Reference: Request for Amendment to Con Edison Solar Project PB approval of October 15, 2020 -  
CMP Interconnection design change

Reference: Request for Amendment to Con Edison Solar Project PB approval of October 15, 2020 - Amended Plan Layout

Project Name: Gardiner Solar Project Project Cost: Appx. \$7 million  
Date of submission: 2021-03-02 Received by: \_\_\_\_\_ Fees: NA

SHEET TITLE  
**FIGURE 1**

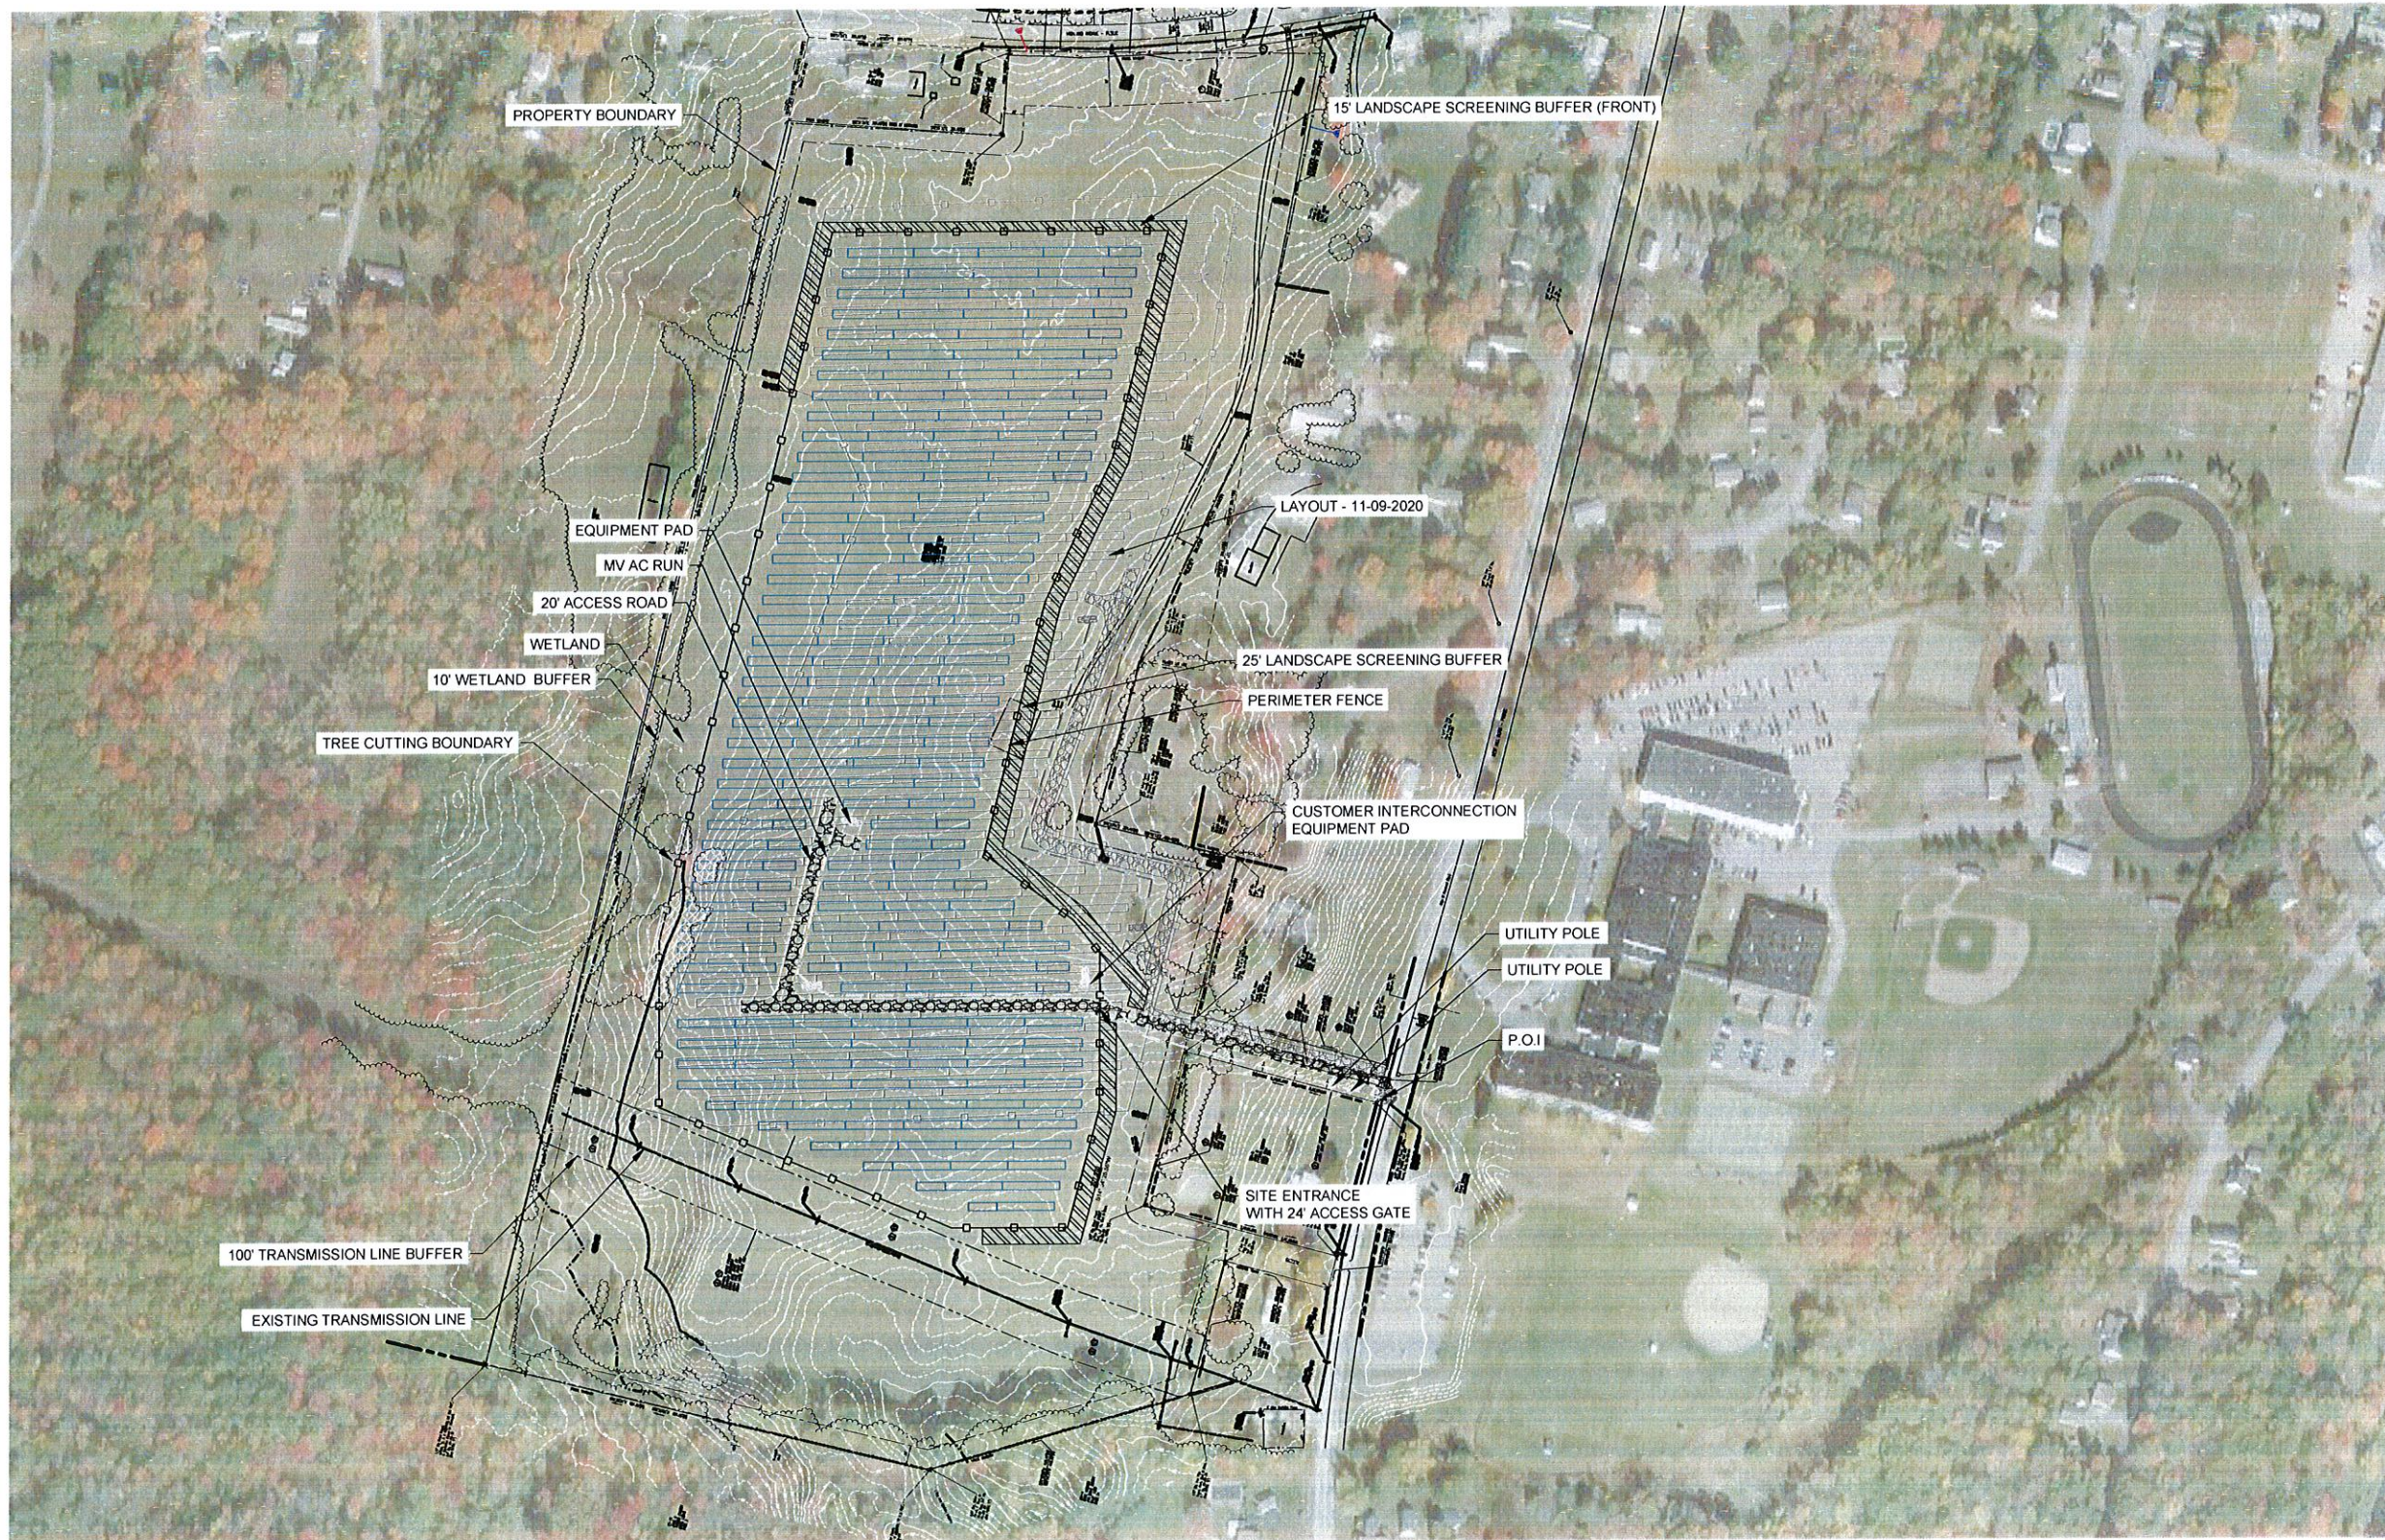
Con Edison Development is submitting revised Figure 1 and Figure 2, specifically to update the proposed interconnection arrangement between our proposed solar farm and the CMP Point of Interconnection (POI) on West Hill Road. This revision is based on the results of a teleconference with CMP to review the interconnection arrangement and to address our plan to connect to the CMP POI using undergrounding electrical lines to a single pole, as depicted on our previously submitted Amendment. During the CMP call it was conveyed to Con Edison Development that 2 poles are required to allow ample room to place CMP equipment on each.

Based on this call we have revised our Figures to reflect this change. Note that all lines from the solar farm to the first pole will remain underground as originally designed. No other changes to the Figures were made and remain compliant with applicable Gardiner performance standards.
